REACTIVITY CONTROL SYSTEMS

BORATED WATER SOURCE - SHUTDOWN

ATTACHMENT "B"

PROPOSED SPECIFICATIONS

REQUIRED STORED BORIC ACID VOLUME AS A FUNCTION OF CONCENTRATION

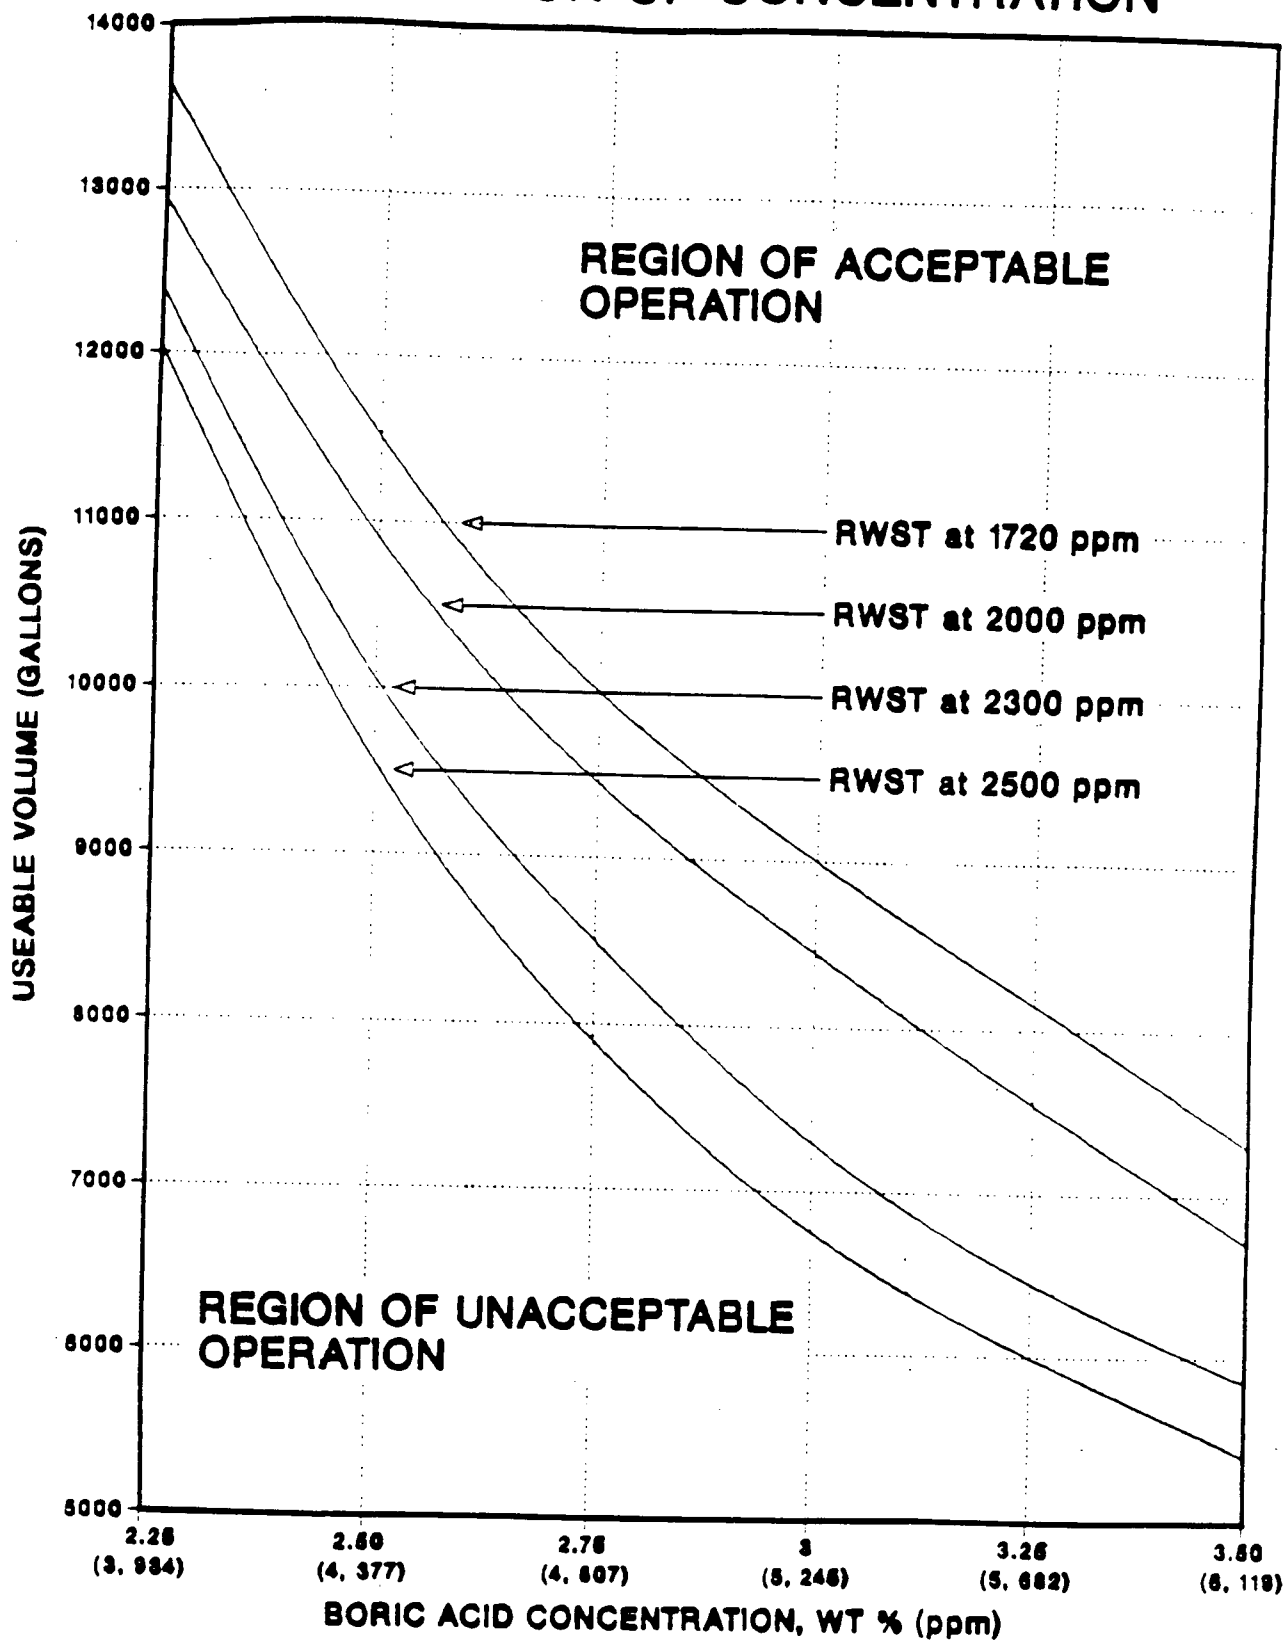
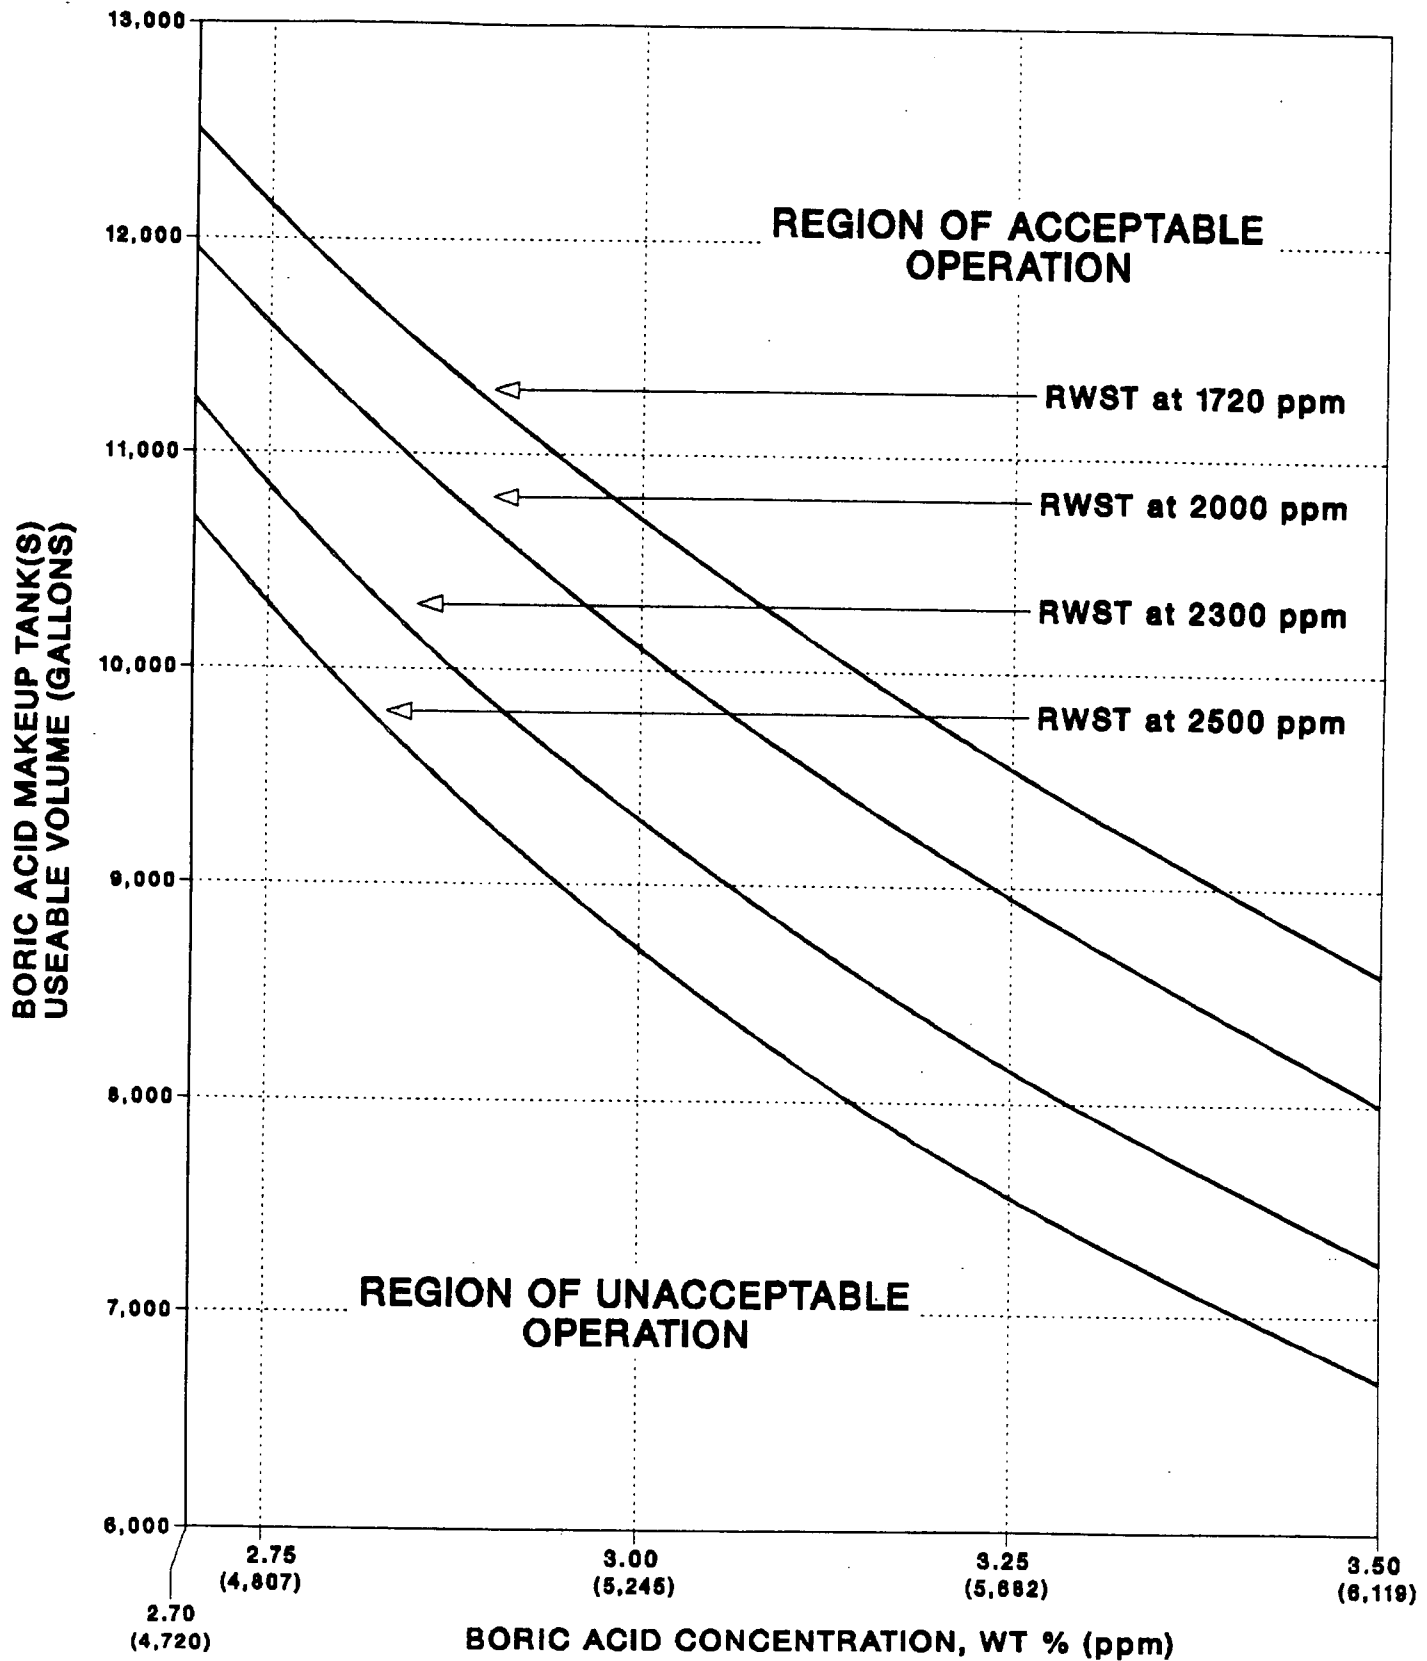
- a. One boric acid makeup tank with a minimum boron concentration of 1720 ppm and a minimum borated water volume of 5150 (7150, Cycle 2) gallons, or
- b. The refueling water storage tanks with:
 1. A minimum borated water volume of 5150 (7150, Cycle 2) gallons above the ECCS suction connection,
 2. A minimum boron concentration of 1720 ppm, and
 3. A solution temperature between 40°F and 100°F.

The boron capability required below 200°F is based upon providing a 3.0% delta k/k SHUTDOWN MARGIN after xenon decay and cooldown from 200°F to 140°F. This condition requires 5150 (7,150, Cycle 2) gallons of 1720 ppm borated water from either the refueling water tank or boric acid solution from the boric acid makeup tank.
